# **Design Modification Request**

Todays date:	Type 1 - \$ <u>500</u> Type 2 - \$ <u>400</u> :
PROJECT INFORMATION	
Project name: Sandy Woods Subdivision Phase 2; SE Kelso Road	
Nearest address or intersection: South of 37117 SE Kelso Road; west of Jewelberry Ave, Sandy	
Functional classification of road:Minor Arterial	
Posted speed:45 mph	
Applicable roadway standard: Cross section, including planter strip, sidewalk width, & retaining wall within the ROW.	
Description of modification & reason for request: Due to jurisdictional wetlands south of the existing roadway three cross section elements area proposed to be modified as noted on the attached sheet.	
Supporting documentation: See attached	
Mitigation for modification: See attached	
Public Benefit: See attached	
APPLICANT	
Name:Patrick Sisul, PE, Sisul Engineering	
Day phone: (503 )657-0188	
Email:patsisul@sisulengineering.com	
PROPERTY OWNER	
Name:Silver "V" Construction, Inc., Rob Venema

# Design Modification Request, SE Kelso Rd:

RE: Sandy Woods Design Modification SC004521

Site Plan

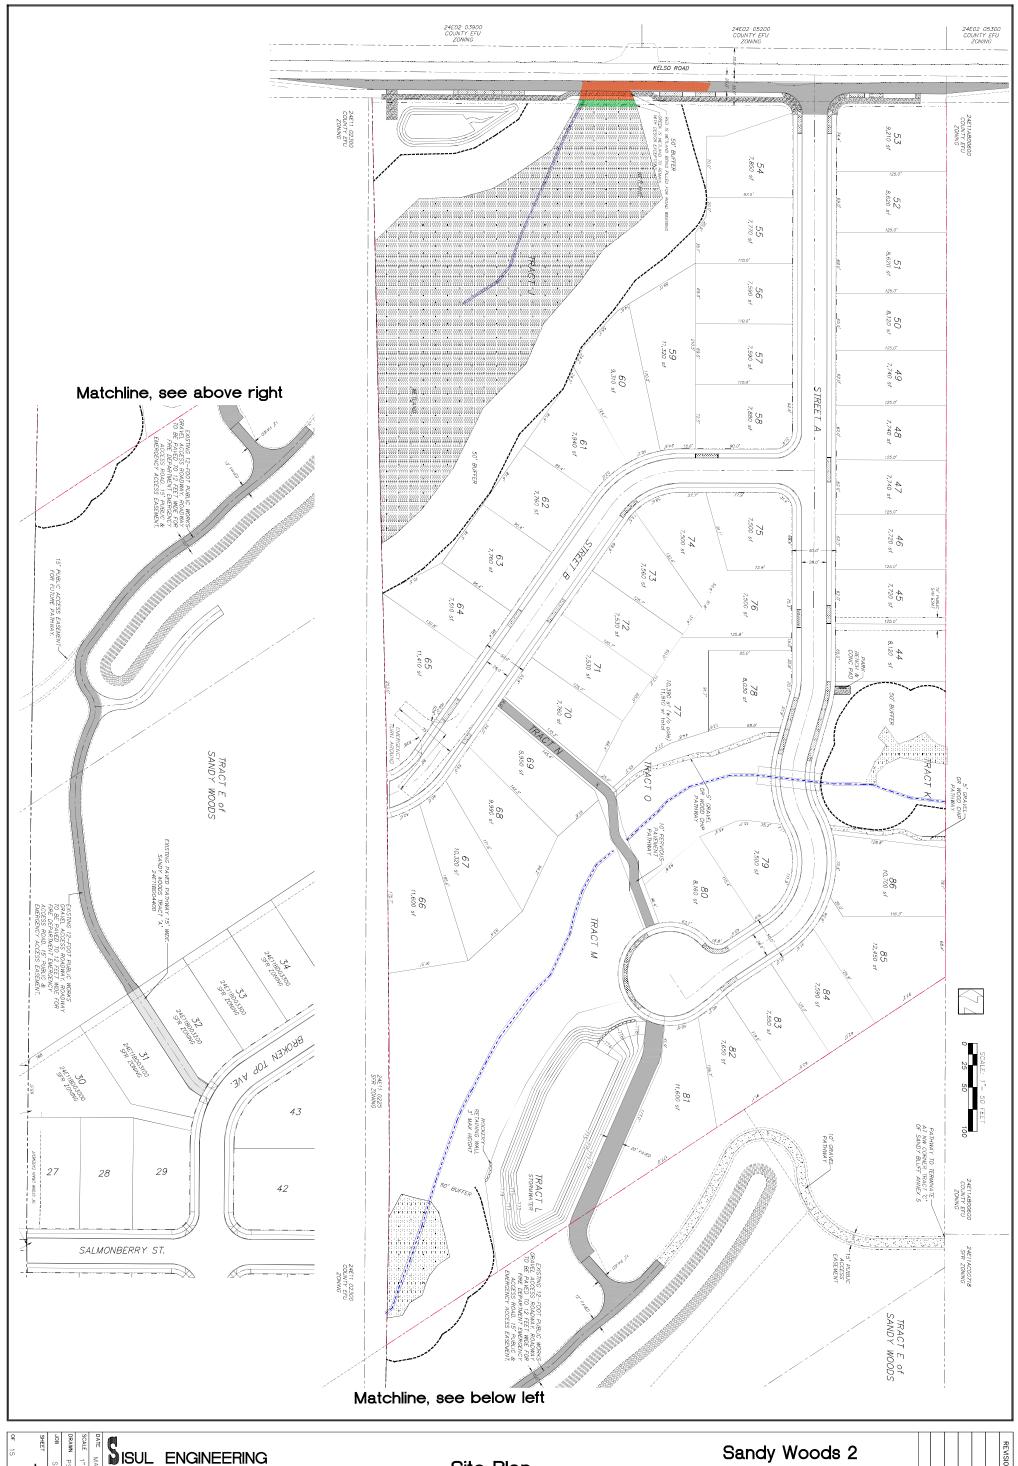
Modify the roadway cross sectional element of Standard Drawing C140 requiring the planter strip and a 6-foot-wide sidewalk for a portion of the site frontage. The applicant is requesting to eliminate the planter strip and reduce the width of the public sidewalk to 5-feet over a 120-foot-long area between Kelso Road stations 15+55 and 16+75. In addition, modify roadway standard 5 c) regarding locating a retaining wall on private property when feasible. The applicant is requesting to place a retaining wall within the public right of way over a 210-foot-long section between Kelso Road stations 14+95 and 17+05, as indicated on the attached plan.

Existing jurisdictional wetlands are located within the southern portion of the SE Kelso right-of-way and immediately south of the right-of-way on Tax Lot 24E11 02204. Oregon Department of State Lands (DSL) has approved wetland delineation studies prepared for the SE Kelso Road right-of-way and for Tax Lot 24E11 02204, which is part of the Sandy Woods 2 site. The wetlands in the right-of-way and on Tax Lot 24E11 02204 are part of larger jurisdictional wetland that extends southwest of the Sandy Woods 2 site and north of Kelso Road. Eliminating the planter strip, reducing the sidewalk width, and minimizing grading by building a retaining wall within the public right-of-way will reduce the impacts to the wetland by 523 sq. ft. Reduction in impacts to wetlands is a priority of the Oregon Department of State Lands.

The proposed modifications would eliminate the planter strip and reduce the sidewalk width to 5 feet along a 120-foot-long section of SE Kelso Road and would place a retaining wall within the right-of-way over a 210-foot distance. Existing trees and vegetation remaining within the wetland would mitigate the for the loss of the vegetation between the curb and sidewalk. To mitigate for the retaining wall being within the right-of-way and the vertical drop behind the sidewalk, a protective guard, compliant with Section 1015 of the Oregon Structural Specialty Code, would be placed along the rear of the sidewalk. Both the retaining wall and the protective guard would be owned and maintained by the Sandy Woods 2 Homeowners Association. Having the retaining wall and the protective guard owned and maintained by the HOA would relieve Clackamas County Roadway Department from any maintenance expense associated with the wall or guard and would mitigate for the retaining wall and protective guard being within the public right-of-way.

The applicant is requesting a modification of standard detail C140 to allow for a 5-foot curb-tight sidewalk along SE Kelso Rd for approximately 120-foot duration from station 15+55 to 16+75. Staff has reviewed the application and found that the allowance of the 5-foot curb-tight sidewalk along the delineated wetland would be in the best interest of the public with minimal disturbance of the adjacent delineated wetland and therefore approved.

In addition to the sidewalk the applicant has requested the allowance of a retaining wall within the county right-of-way at two locations. The first location would from station 14+95 to 17+05 and the second would be at station 19+95. Chapter 5 of the Clackamas County Roadway Standards states that retaining wall should be located on private property and easements shall be provided as necessary. Staff has determined that the allowance of the retaining wall within the county right-of-way is <u>not</u> in the best interest of the public and both retaining walls can be constructed and maintained within the adjacent private property and within an easement. Therefore, the applicant's request for the retaining walls to be located within the county right-of-way is <u>not</u> approved. All private structures, including supporting devices, shall be located within the public utility, sidewalk and slope easement and completely outside the county right-of-way. Increased width of the public easements may also be required if deemed necessary.

Subsequently due to the existing grading for half-street improvements and right-of-way dedication requirements, the applicant has requested to allow the sidewalk to end approximately 5-feet short of the easterly property line. This allowance would allow grading to occur within existing county right-of-way without slope easements or grading on adjacent properties. This design modification is approved.

As a whole, this design modification is partially approved for sidewalk width and length and not approved for private structures within the county right-of-way.
